## **DEVIATION REQUEST AND DECISION FORM**

Project Name : Waterbury Filing No. 1  
Schedule No.(s) : 420000417  
Legal Description : Waterbury Filing No. 1

A deviation from the standards of or in Section **DCM 10.5.4, 10.7, and DCM Update 9.0-9.1 per ECM 3.3.3.B.** is requested.

CONSTRUCTION SET  
WEST CHANNEL - CHANNEL IMPROVEMENTS PLAN

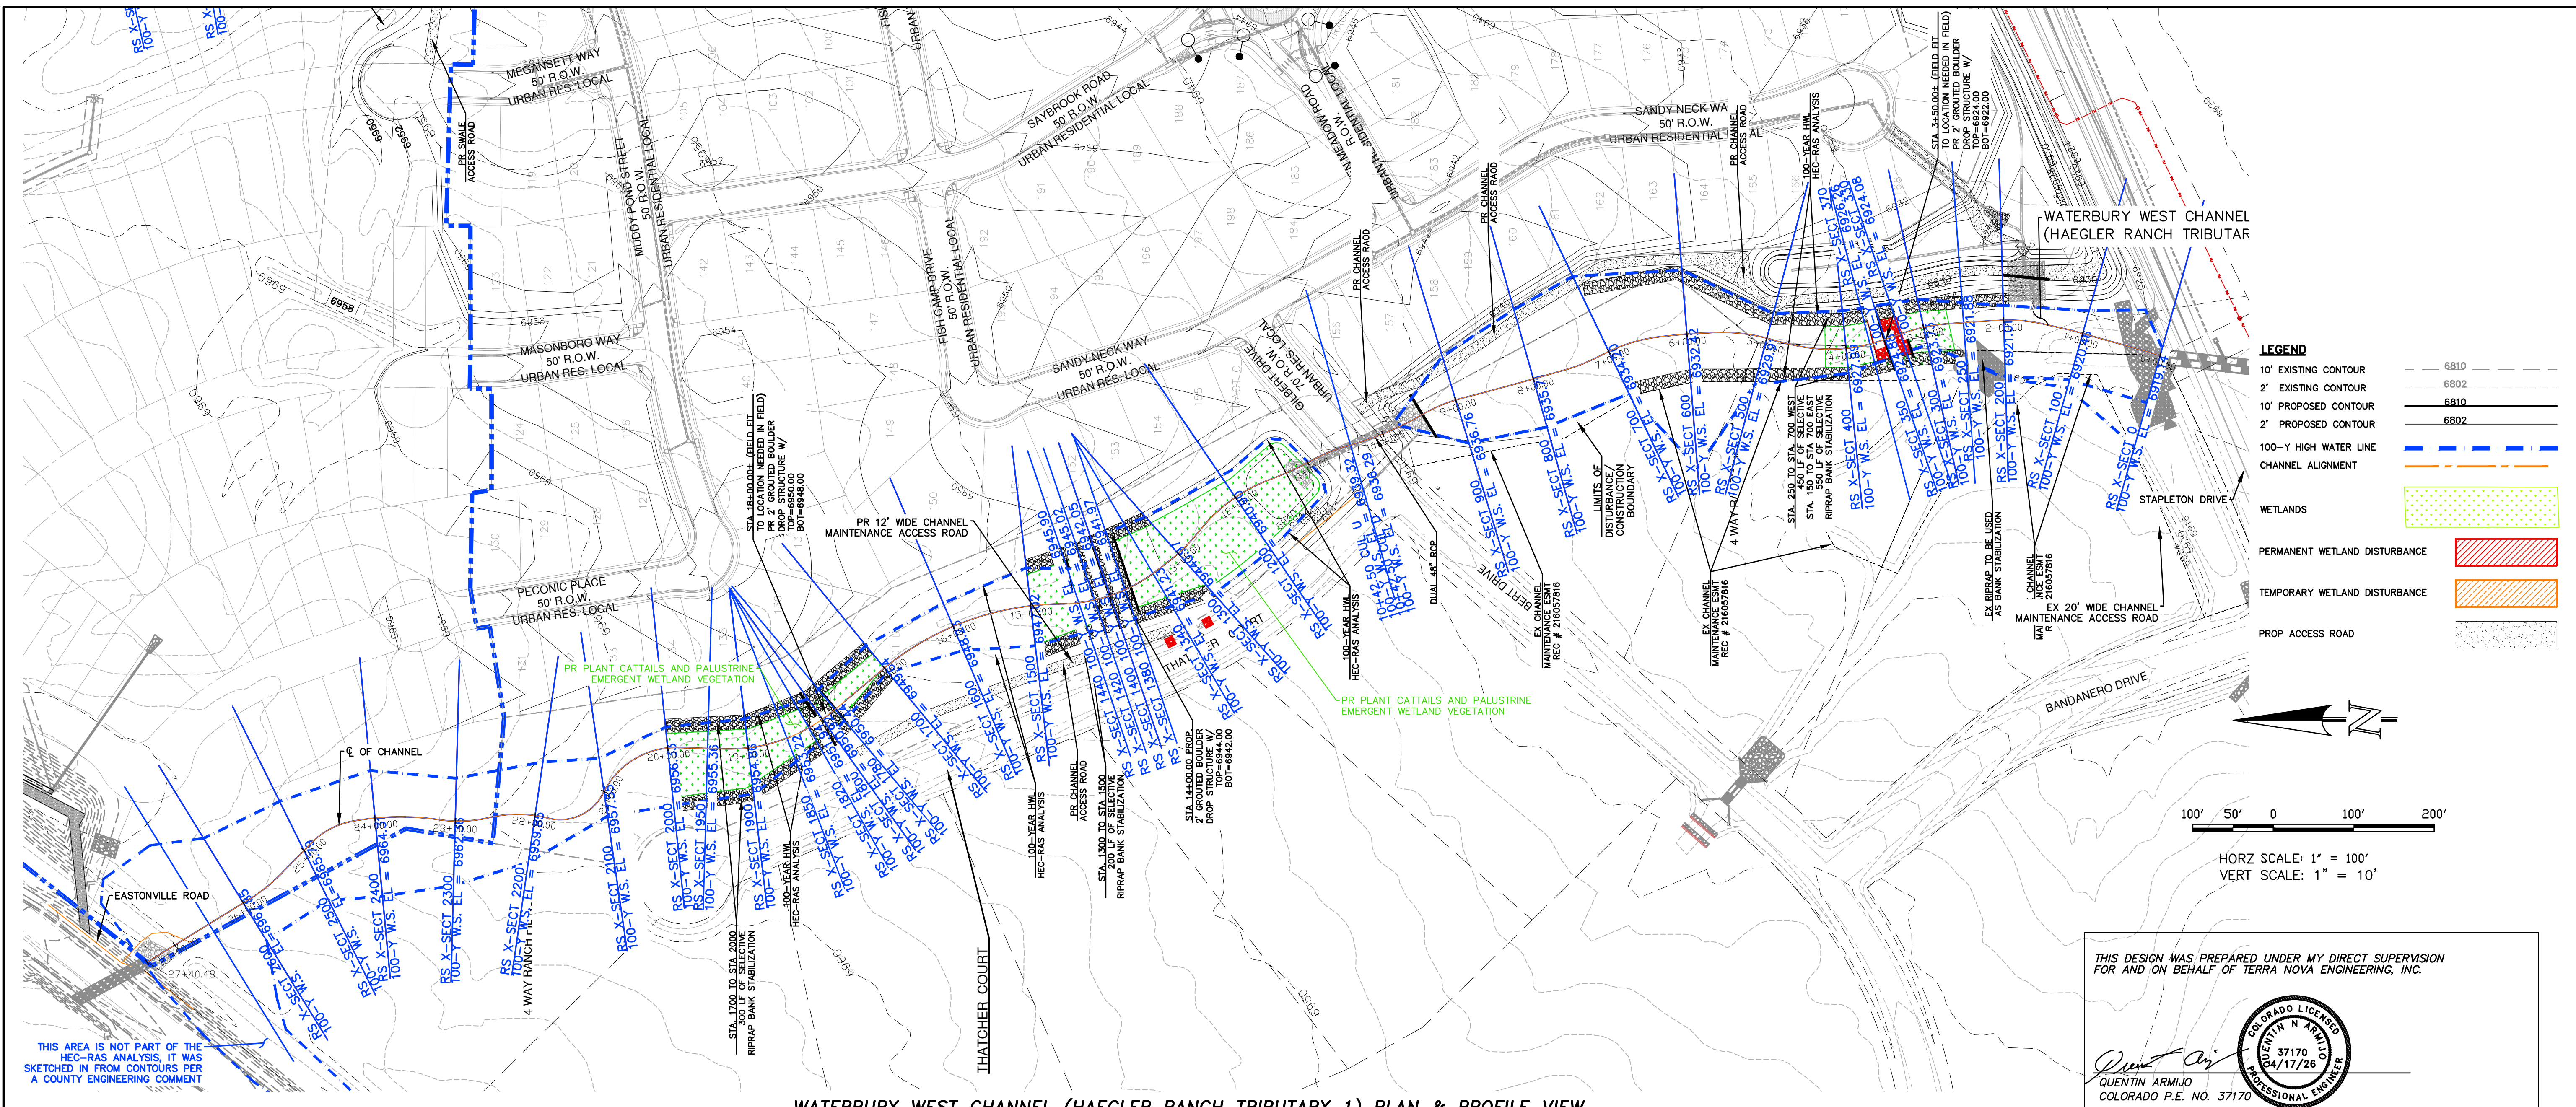
An alternate for the West Channel in the 100-Year event is to armor the channel sides, provide drop structures and plant cattails and palustrine emergent wetland vegetation. We are proposing to do just that with the construction drawings at these locations listed below in the 100-Year event.

In the 100-y event RS x-section **1820** is shown as supercritical the velocity is 5.06 fps, the Froude number is 0.91 and the shear stress is 2.63 lbs/sq ft, this cross section is at the top of a proposed grouted riprap drop structure with armoring on the sides and being re-vegetated. This is the proposed alternative to resolving the issue.

In the 100-y event RS x-section **1800** is shown as supercritical the velocity is 5.25 fps, the Froude number is 1.01 and the shear stress is 2.98 lbs/sq ft, this cross section is a proposed grouted riprap drop structure with armoring on the sides and being re-vegetated. This is the proposed alternative to resolving the issue.

In the 100-y event RS x-section **1420** is shown as supercritical the velocity is 4.00 fps, the Froude number is 1.01 and the shear stress is 2.07 lbs/sq ft, all below the erosive limits shown in Table 8.3 this cross section is a proposed grouted riprap drop structure with armoring on the sides and being re-vegetated. This is the proposed alternative to resolving the issue.

In the 100-y event RS x-section **350** is shown as supercritical the velocity is 5.25 fps, the Froude number is 1.01 and the shear stress is 8.09 lbs/sq ft, this cross section is a proposed grouted riprap drop structure with armoring on the sides and being re-vegetated. This is the proposed alternative to resolving the issue.

**WATERBURY EAST CHANNEL PLAN & PROFILE VIEW**  
 HORZ SCALE: 1"=100' - VERT SCALE: 1"=10'

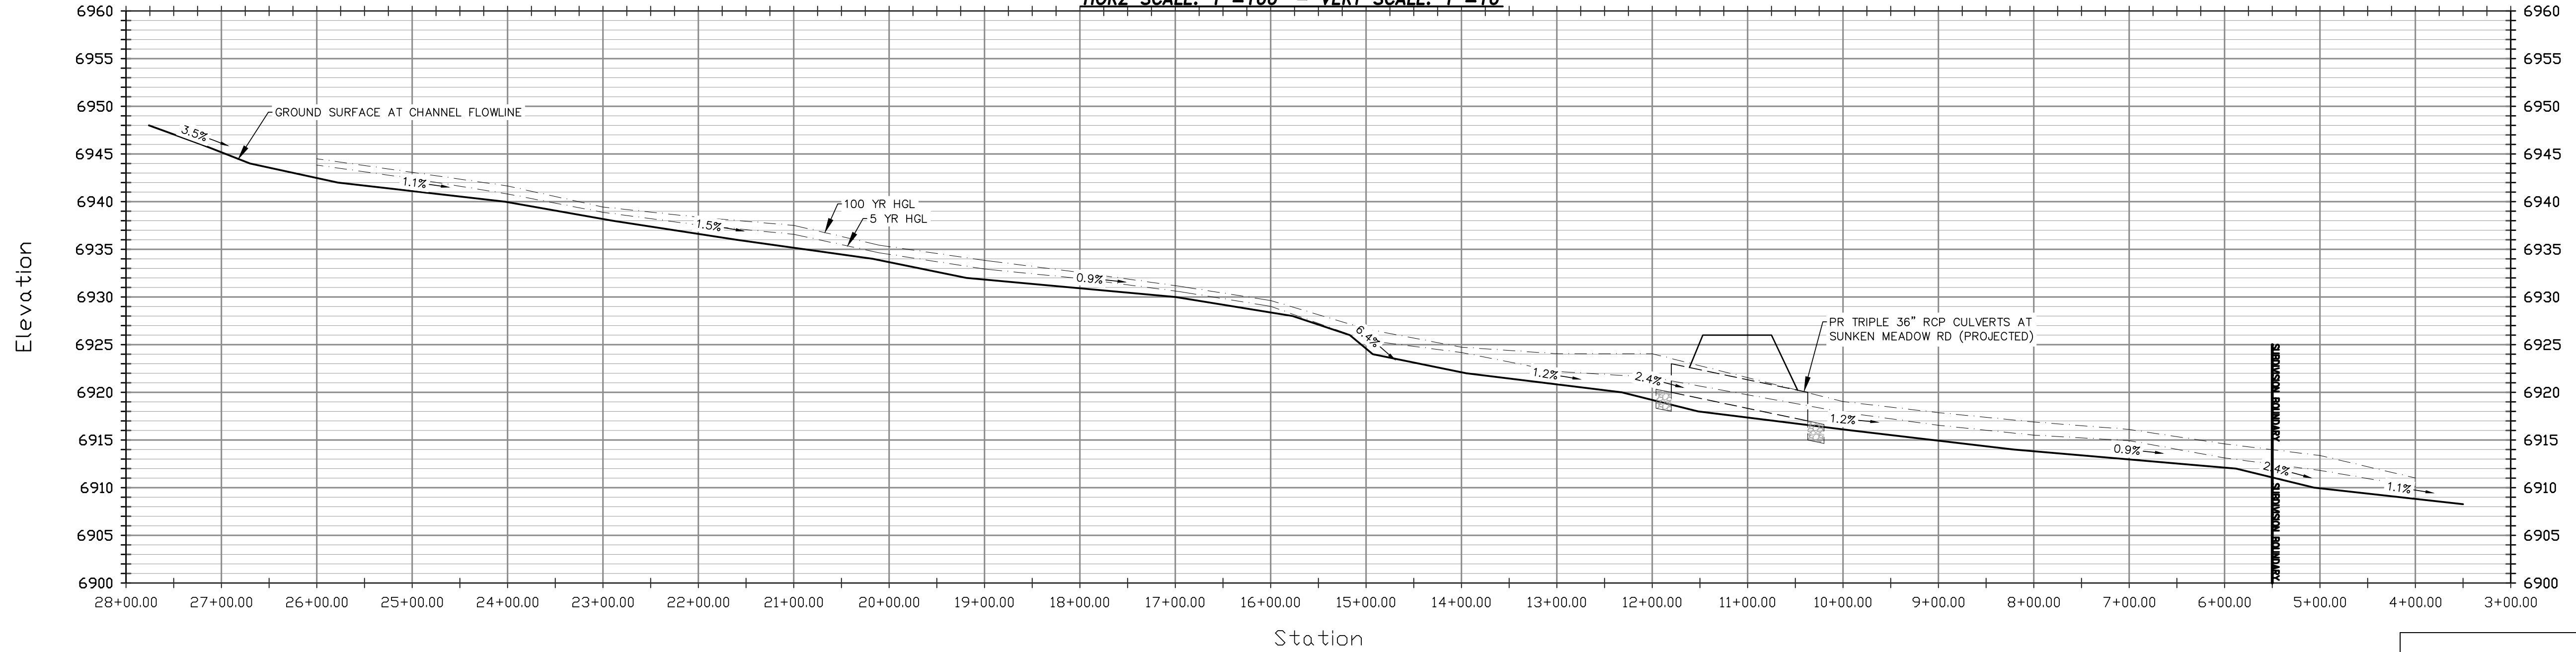
An alternate for the East Channel is to armor it or provide drop structures and we are arguing that we do not need to disturb the East Chanel due to the established wetlands and vegetation that currently show no signs of degradation from past storm events. In Walking the site with an El Paso County Engineer, the East Channel showed it is performing fine as it currently is.

The East channel has no supercritical RS x-sections in the 100-y event and 3 in the 5-y event (RS sections **2010.45, 1300, & 600**)

In the 5-y event RS x-section **2010.45** is shown as supercritical, the Froude number is 0.98 which is above the allowable 0.7 but the velocity is 3.34 fps and the shear stress is 2.63 lbs/sq ft, shows it is not erosive and with no shown degradation or erosion the proposed alternative is to leave it as.

In the 5-y event RS x-section **1300** is shown as supercritical, the Froude number is 0.98 which is above the allowable 0.7 but the velocity is 3.34 fps and the shear stress is 2.57 lbs/sq ft, shows it is not erosive and with no shown degradation or erosion the proposed alternative is to leave it as.

In the 5-y event RS x-section **600** is shown as supercritical, the Froude number is 0.92 which is above the allowable 0.7 but the velocity is 3.79 fps and the shear stress is 2.57 lbs/sq ft, shows it is not erosive and with no shown degradation or erosion the proposed alternative is to leave it as.
